Land at Bird In Eye Farm, South Of Bird In Eye Hill, Framfield (WD/2021/2198/MAO) – Lead Local Flood Authority position

Date: 2 August 2023

Summary of the Lead Local Flood Authority’s position on the proposed development at Land at Bird In Eye Farm, South Of Bird In Eye Hill, Framfield, TN22 5HA, which will be included in Wealden District Council’s Statement of Case for APP/C1435/W/22/3307820.

**SUD/WD/21/023/R6 - Amendment to Appeal
OUTLINE PLANNING APPLICATION FOR THE ERECTION OF UP TO 290 DWELLINGS,
ASSOCIATED LANDSCAPING, INFORMAL OPEN SPACE AND STRATEGIC SANG, WITH
ACCESS FROM THE B2102., Land at Bird in Eye Farm, South of Bird in Eye Hill,
Framfield, TN22 5HA**

Figure 1: Extract from ESCC Surface Water Flood Risk Dataset

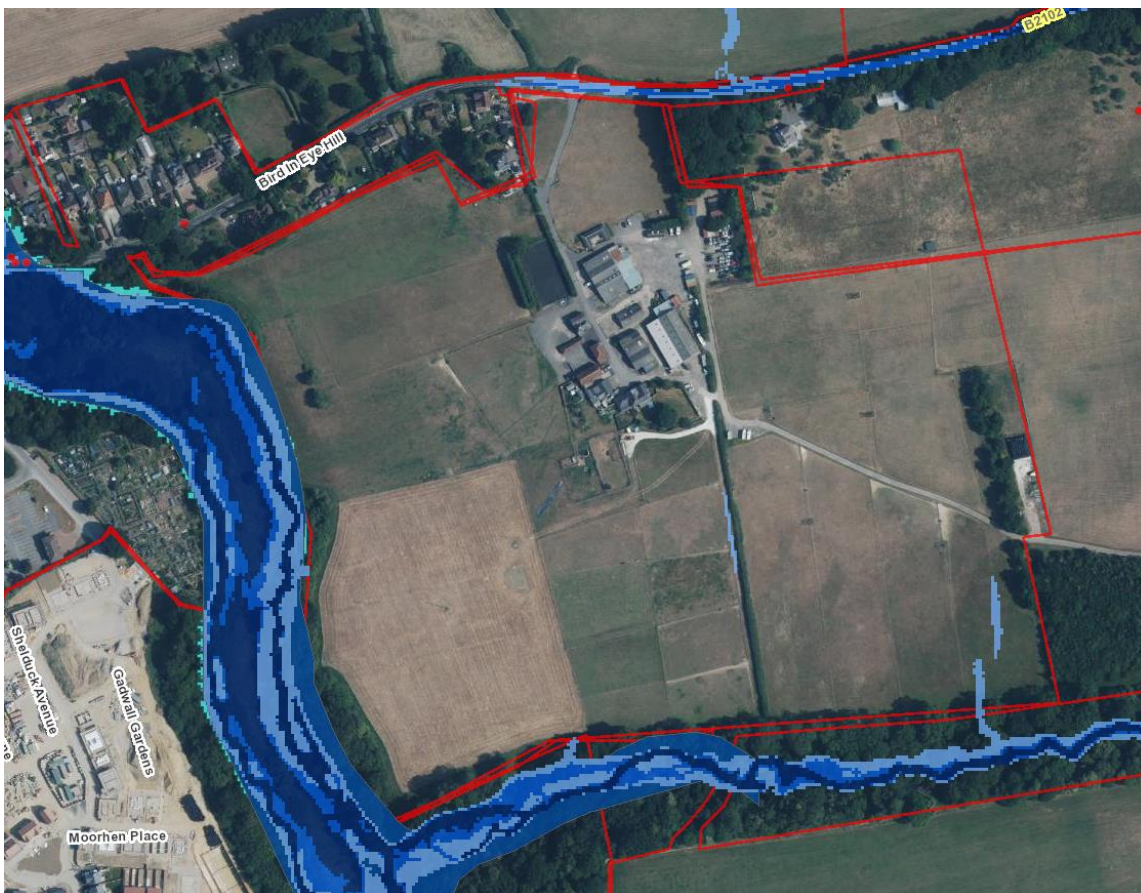
There is no significant flood risk to the development from external sources as identified by the planning submission or in our data sets. There are some small areas of surface water flood risk indicated in the modelling but not to the degree that would be a hazard to the development or materially reduce the ability of the proposed drainage system to function as intended.

An extract of our flood risk data sets is shown below in Figure one with the site outlined in red against the aerial photograph background. For context the light blue shading is the extent of flood risk for the 1000 year return period flood risk from surface water modelling.

Figure 2: Extract from Stantec drawing 48494/2002/SK05 rev A

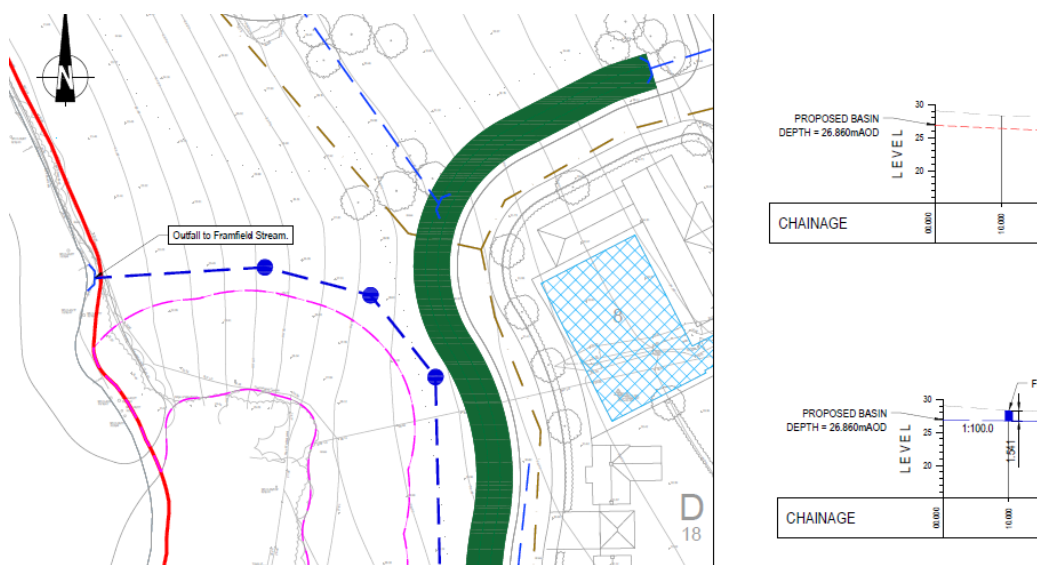
The original basis for the drainage strategy was to discharge to the adjacent watercourse. This was since altered to be an infiltration solution to avoid the need to undertake works in the designated ancient woodland or buffer. Following further ground investigation results, which were unfavourable, this has been returned to the original solution, albeit with a point of discharge further upstream. The proposed outfall is shown in figure 2 below which is an extract from the Stantec Technical Note dated January 2023 titled '*Technical Summary – Surface Water Drainage Strategy*'.

We do not object to the solution. Our only material concern is that the proposed outfall is shown on the plans just outside of the site boundary and therefore may be 'offsite works'. Our position is that as an engineering operation in planning terms and to ensure ownership and/or control of the land to ensure the works can be constructed and maintained in perpetuity without reliance on a third-party consent, all drainage works should be within the site boundary and legal ownership of the applicant. Alternately a legal agreement with a third-party landowner would need to be established.

We understand from the Applicant's Consultant that the land is within the ownership of the applicant, who is the riparian owner of the watercourse bank. Therefore, in our view, and given the close proximity of the works to the site boundary, either a unilateral undertaking can be provided to confirm the outfall can be constructed and maintained in perpetuity for the lifetime of the development by the freeholder of the development and any subsequent management company or adopting body, or alternatively the design and/or planning red line could be clarified to contain all drainage works within the site.

This is essential to ensuring the outfall, being the only viable option to drain the site, remains in under the control of the owner of the development land, whether sold or retained by the current owner.

Should the Planning Inspector be minded to grant this appeal, we request that the ability to construct, access the outfall in perpetuity (for maintenance), and to discharge surface water to the watercourse is legally established as part of the planning process for the lifetime of the development. The following condition can then be applied to the Outline Planning Consent to control the detailed design and successful implementation of the drainage system:
